Concorde Garments Ltd (Extension)

21 November 2023

Structural Inspection Report

Prepared load plan on 3rd floor

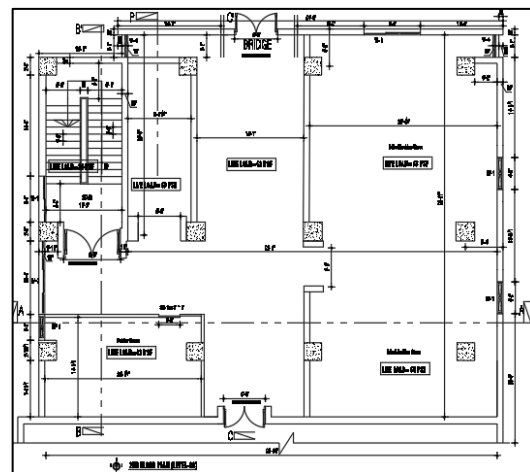
Description: Live load on storage area of 2nd floor is considered as 3 kPa in prepared load plan. As per BNBC-2006, live load for light storage areas is required to be considered minimum 6 kPa. Therefore, the factory engineer is required to revise the load plan as per BNBC requirement and check the design accordingly.
